ADDENDUM NO. 2

Reference: Electrical Distribution Upgrade – Camp Williams
Utah National Guard – Bluffdale, Utah
DFCM Project No. 07167480

Subject: **Addendum No. 2**

Spoil Dump Location

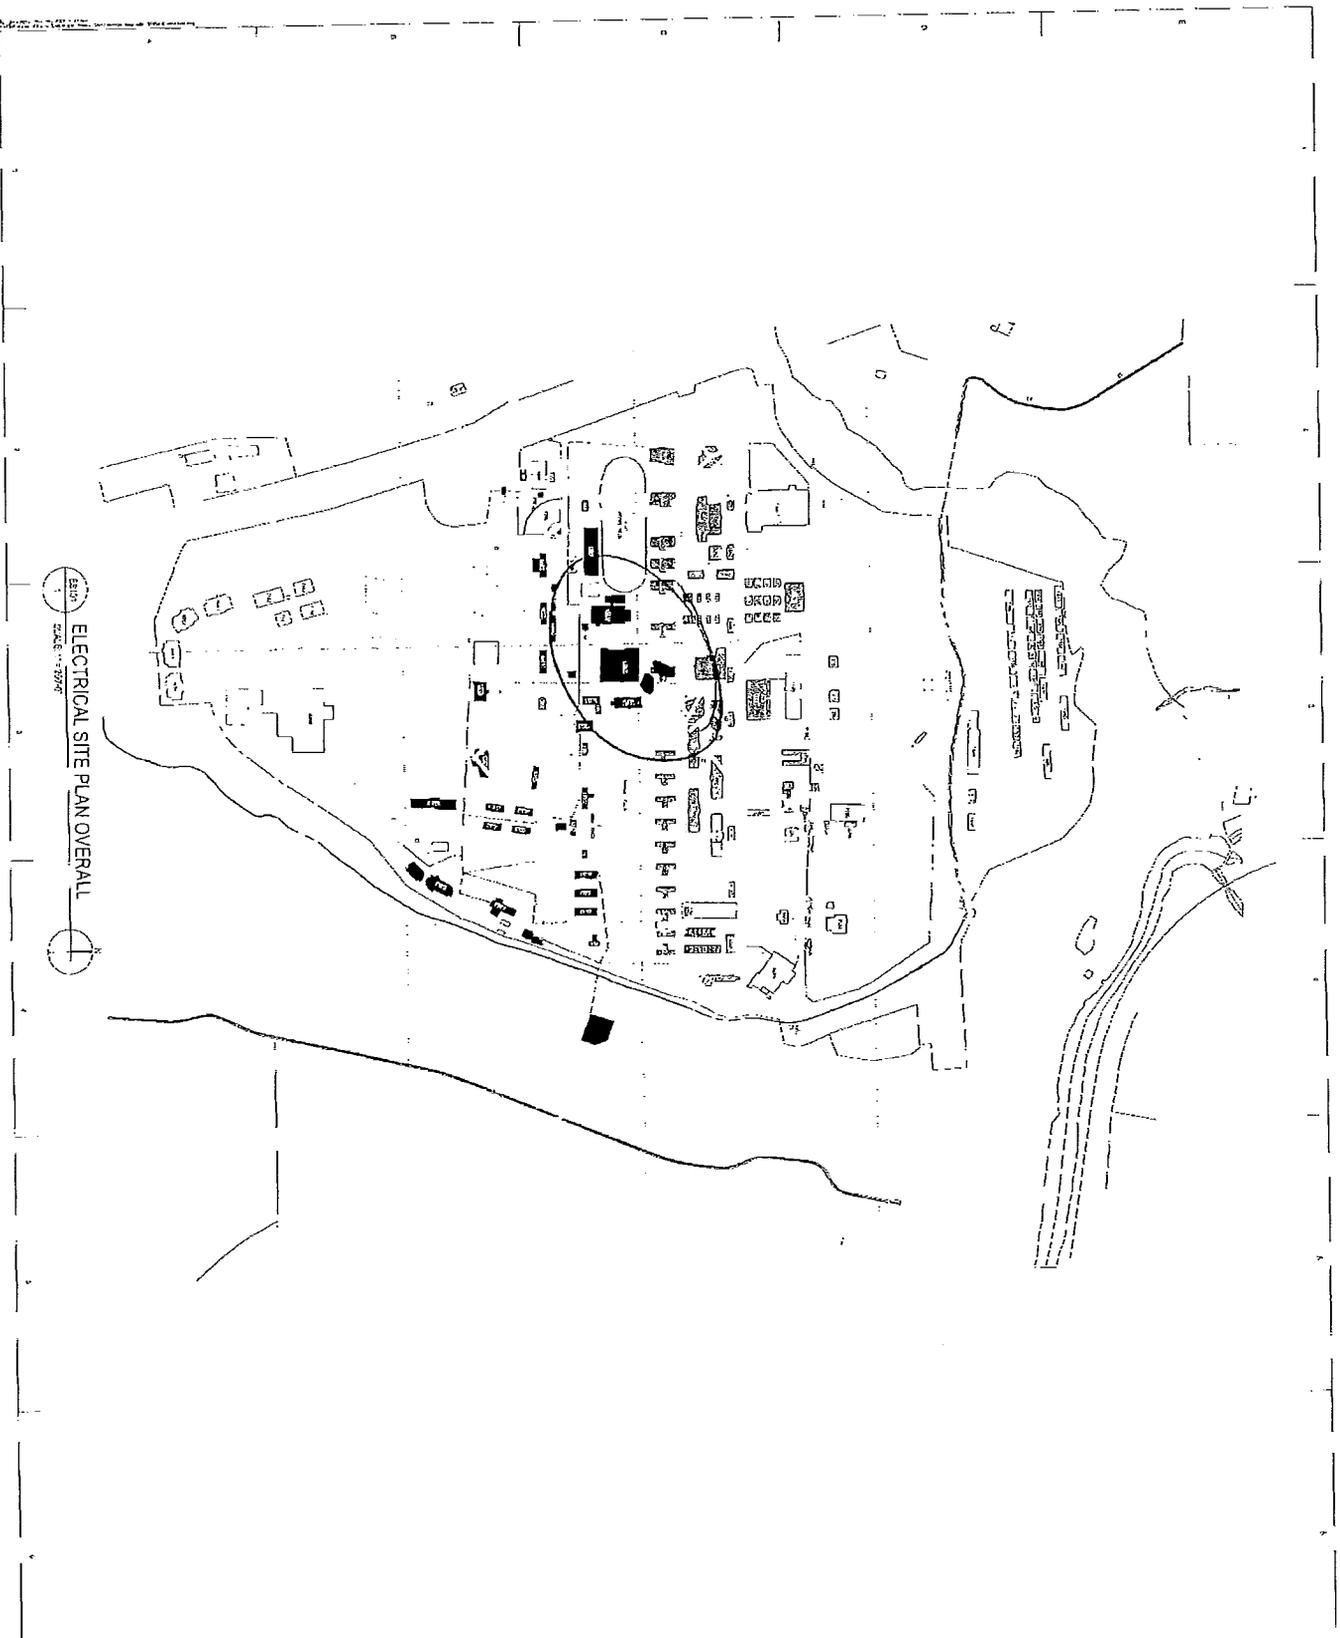
29. See attached sheet for spoils dump site. This site is a suggested dump site, however, the contractor may also take spoils off the base and dispose of in a legal manner if desired. Please note that this is only for rock and dirt dumping. All debris, asphalt and concrete shall be removed and dumped offsite at another location as determined by the contractor and at the contractor's cost.
